1250 Maryland Avenue
1250 MARYLAND AVENUE SW
WASHINGTON, DC 20024

SLAB EDGE - LEVEL 09 TO
10

SK#25
7 pages
11 Queries
Date: 07-14-2025

A057

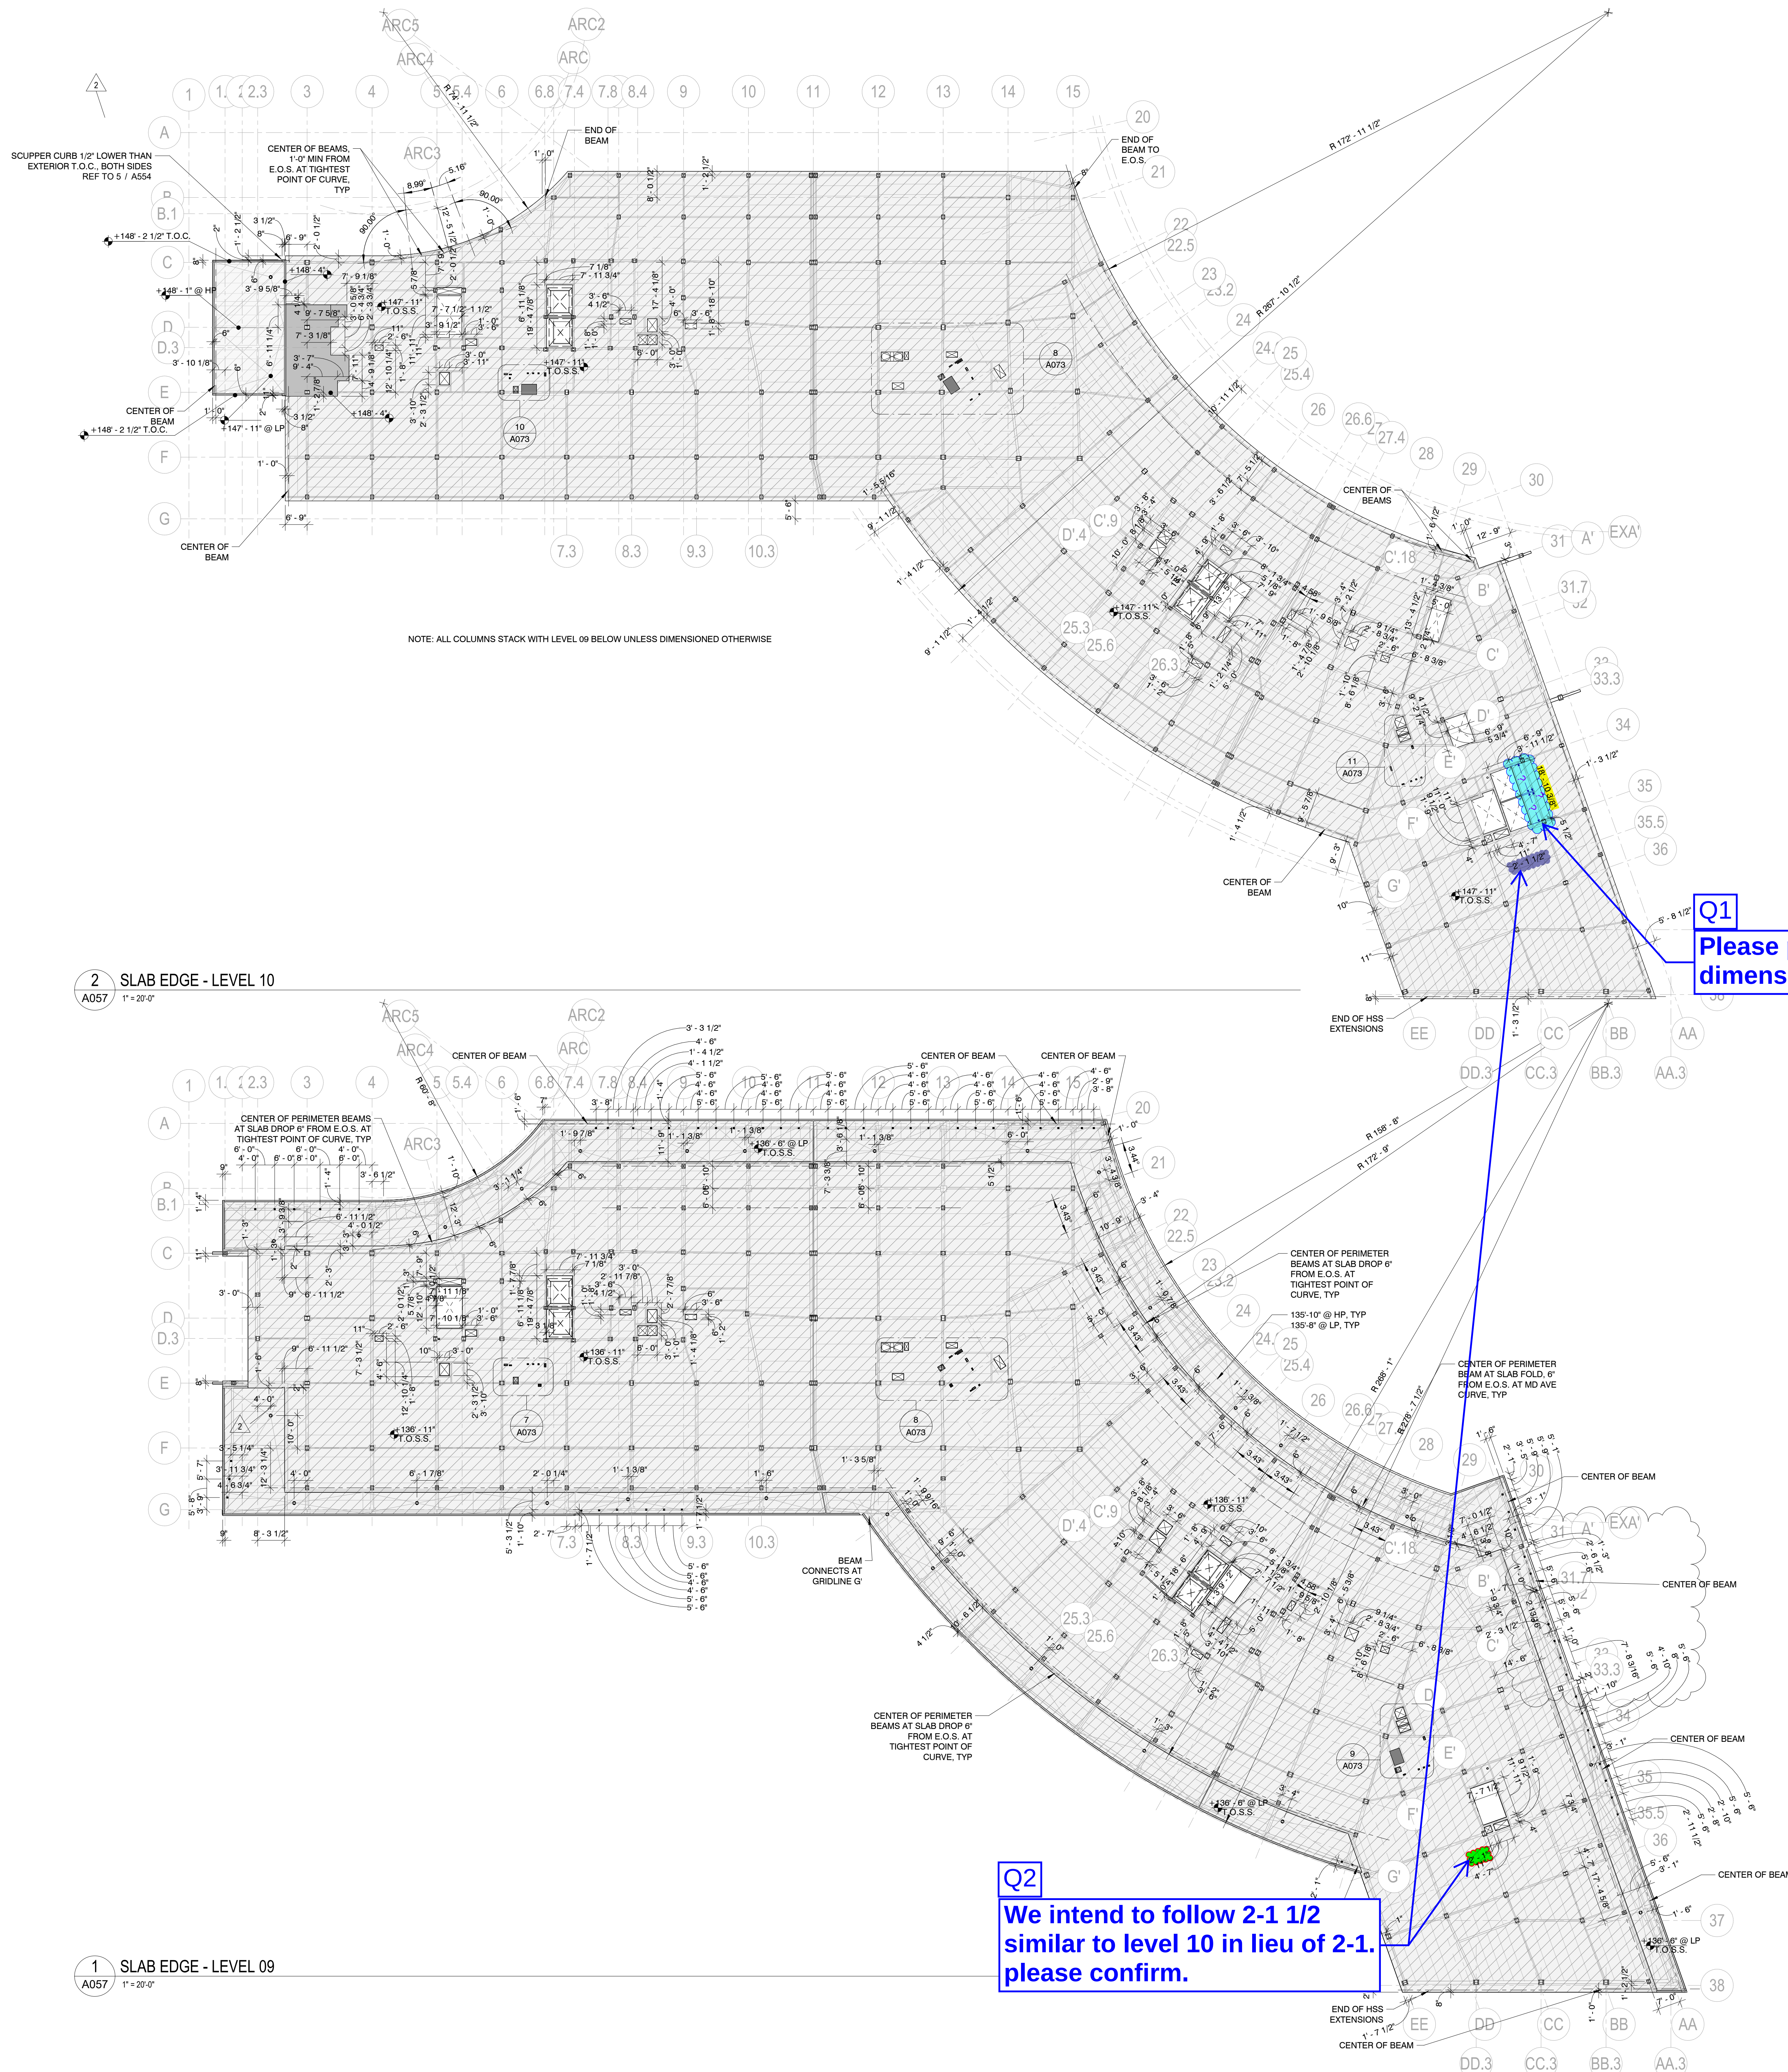
Q2
We intend to follow 2-1 1/2 similar to level 10 in lieu of 2-1. please confirm.

1 SLAB EDGE - ENLARGED PLAN LEVEL 11
A071 1/4" = 1'-0"

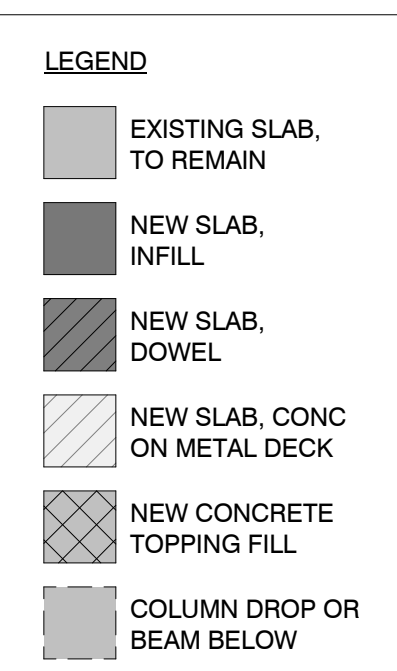
Snap from Arch. drawing 8/A073

8 ENLARGED SLAB EDGE - LEVEL 9-2 (LEVEL 10 SIM)

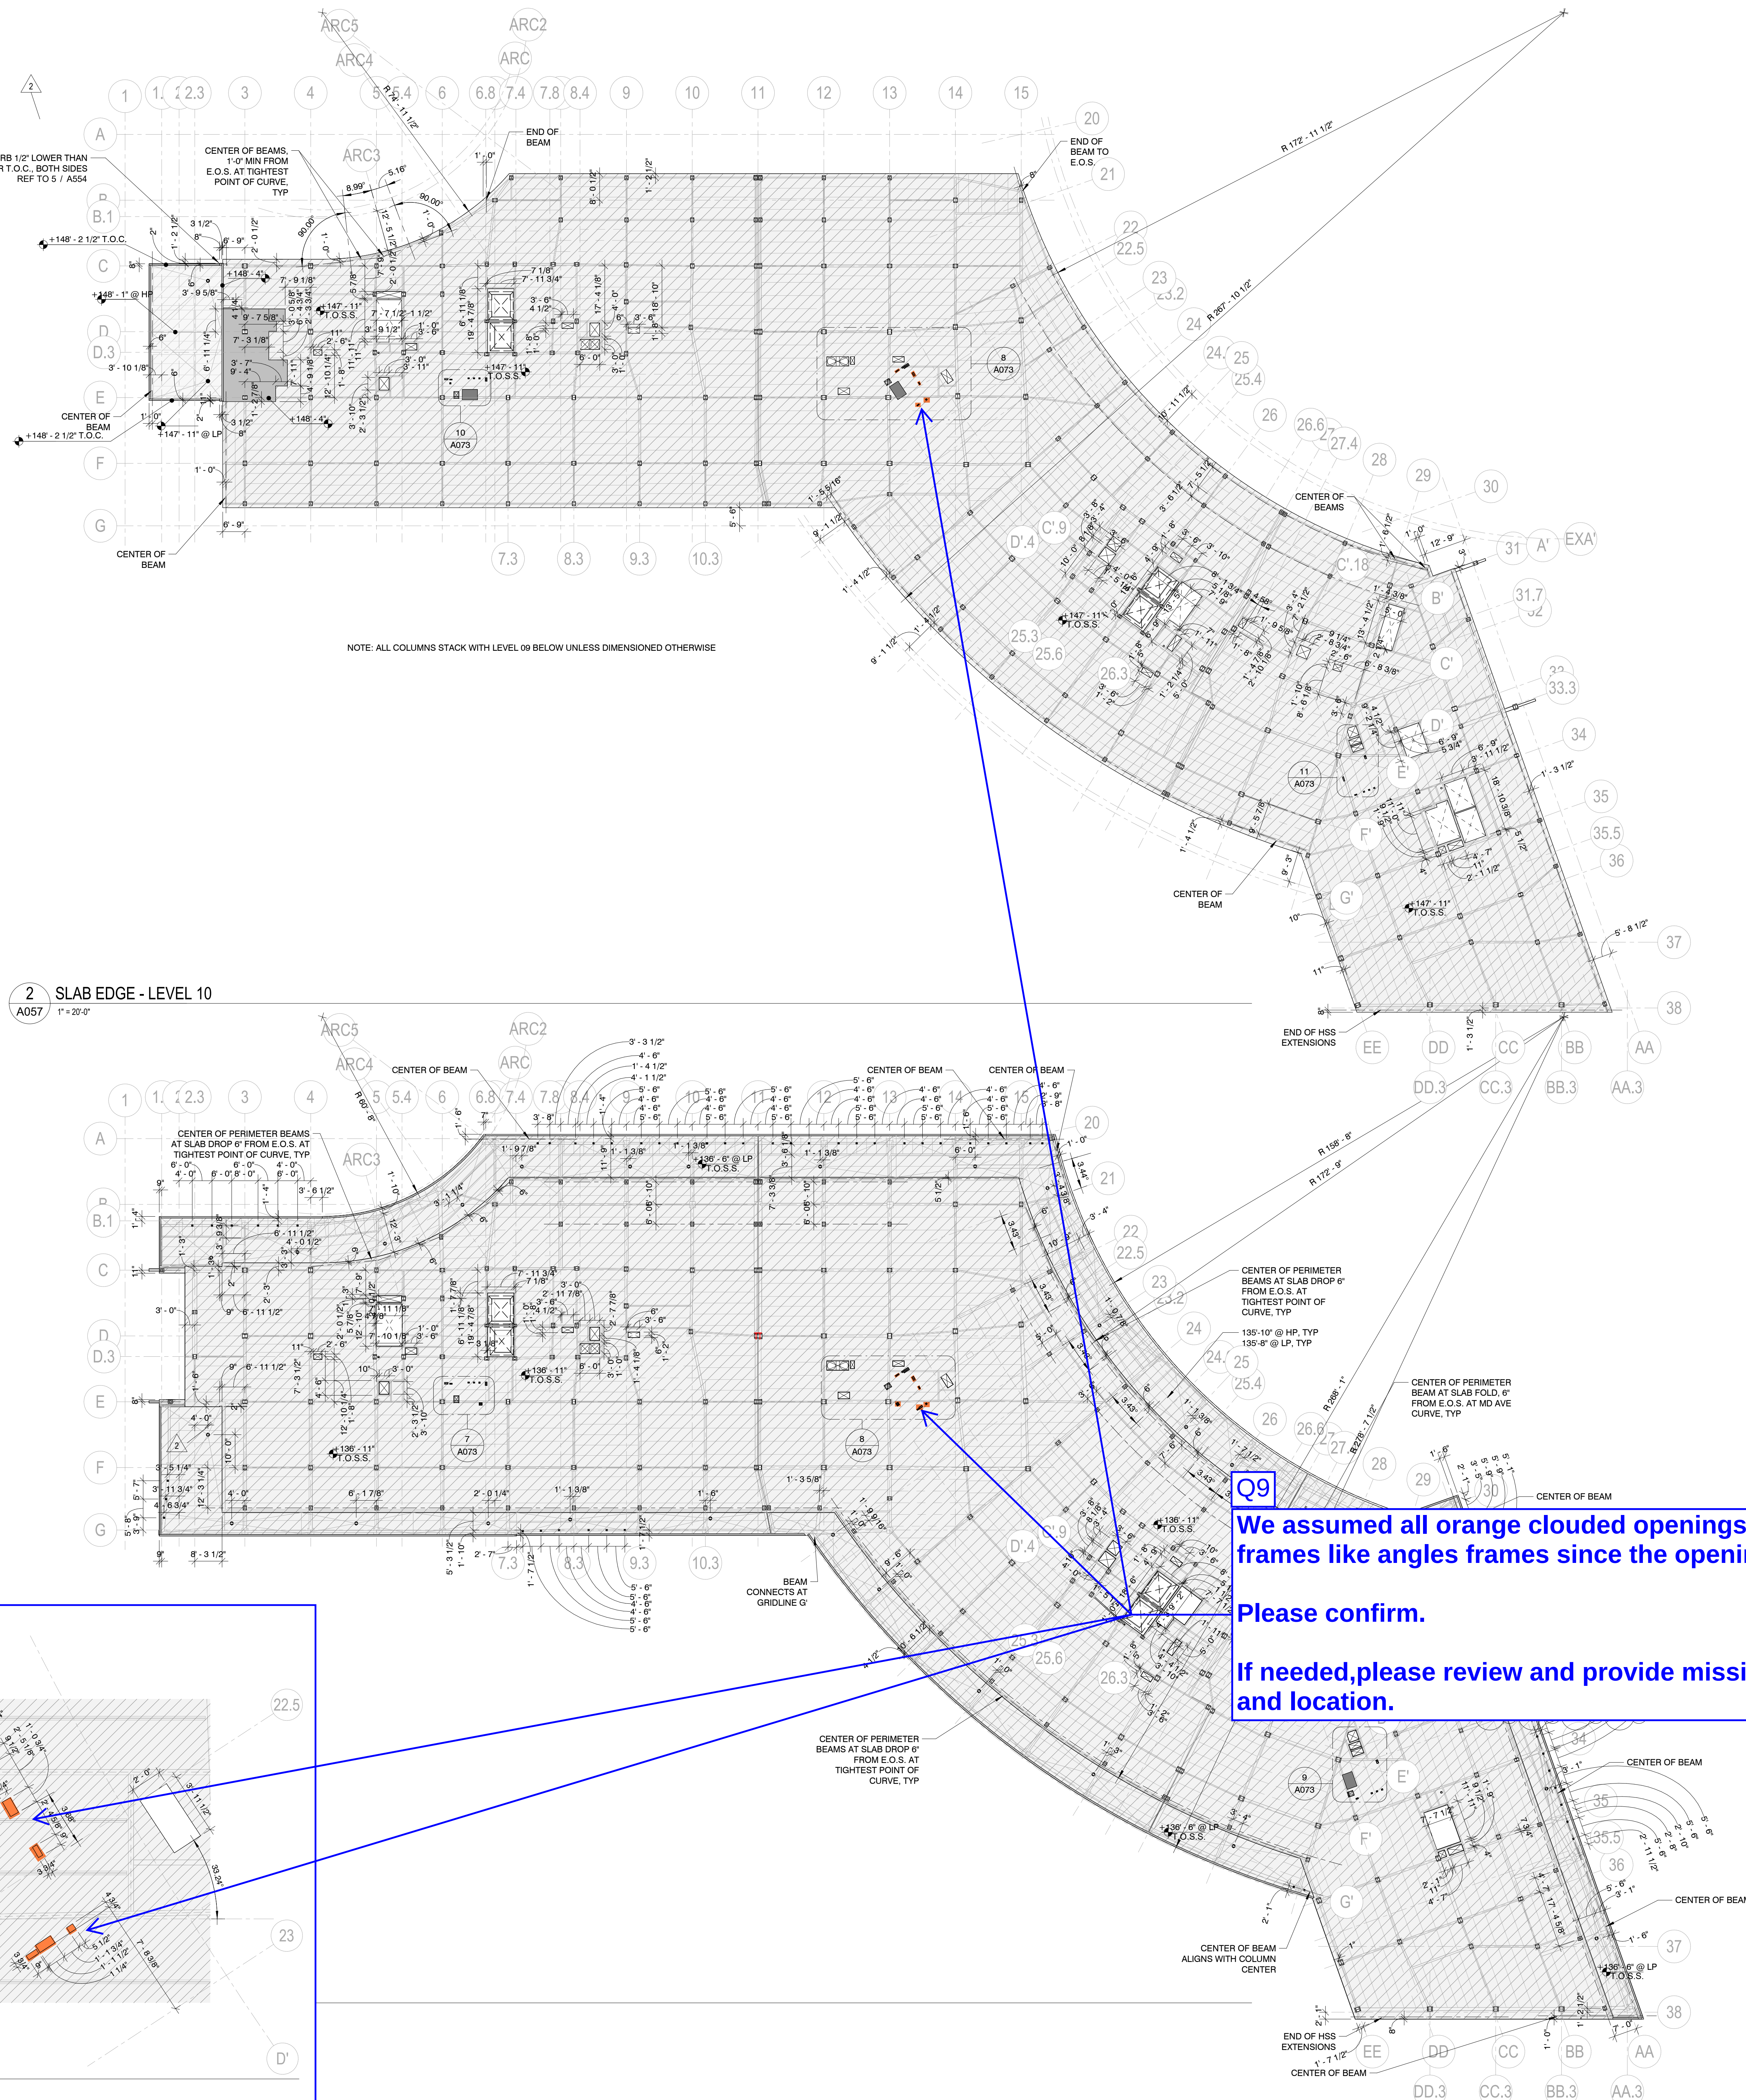
We assumed all orange clouded openings will NOT required support frames like angles frames since the opening sizes are small (less than 1-2).

Please confirm.

If needed, please review and provide missing dimension for opening size and location.
